**STAFF REPORT: SEPTEMBER 13, 2023 REGULAR MEETING**

**APPLICATION NUMBER: 23-8536**

**ADDRESS: 13201 DEXTER**

**SCOPE: INSTALL STONE AND STUCCO VENEER**

*Proposed light fixture. Image from application.*

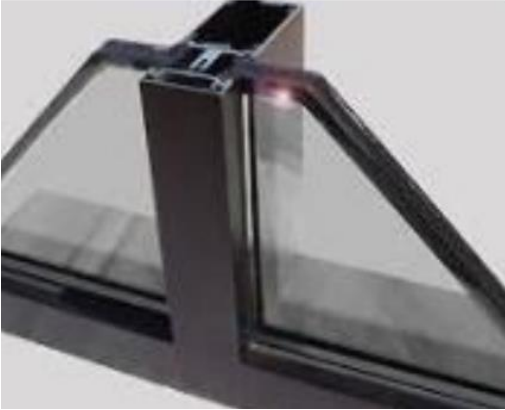
- The proposed work removes non-historic lighting. The proposed light fixtures are both compatible, as wall-mounted downlighting is appropriate for mid twentieth-century commercial architecture, and clearly differentiated, as their contemporary design would not be readily mistaken for a historic feature.

Front (east) door. September 2023 photo by staff.

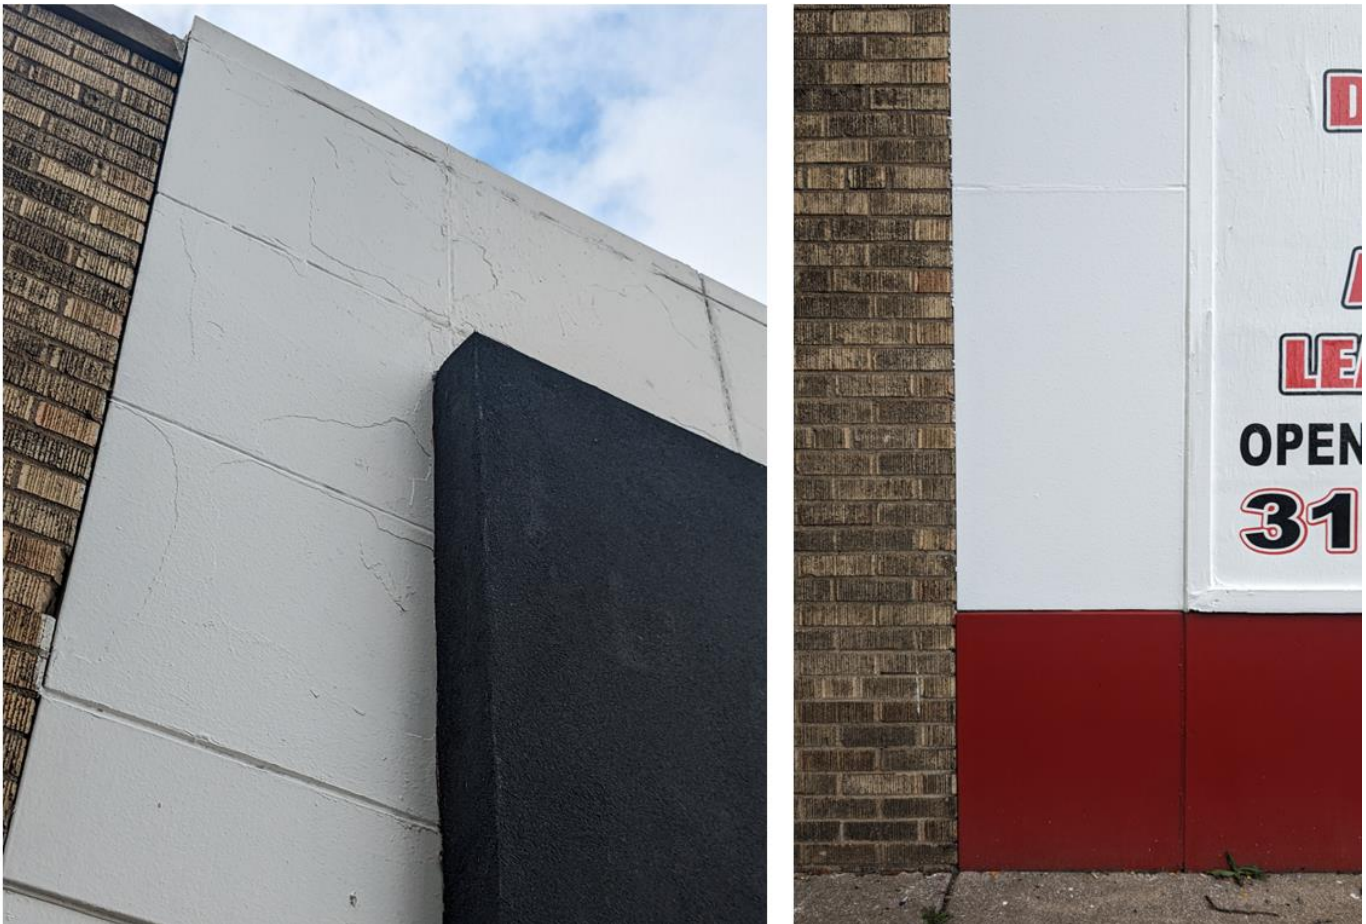
- The door is a historic element that has not been shown to be deteriorated beyond repair. Further, the application does not provide specifications for the proposed replacement door.

- The proposed composite deck board cladding, providing a stark contrast with the other storefronts on the same building and the other buildings on the block, would disrupt the “repetitive flow of storefronts” described in the Elements of Design.
- The proposed door replacement would remove a historic element that is not deteriorated beyond repair.
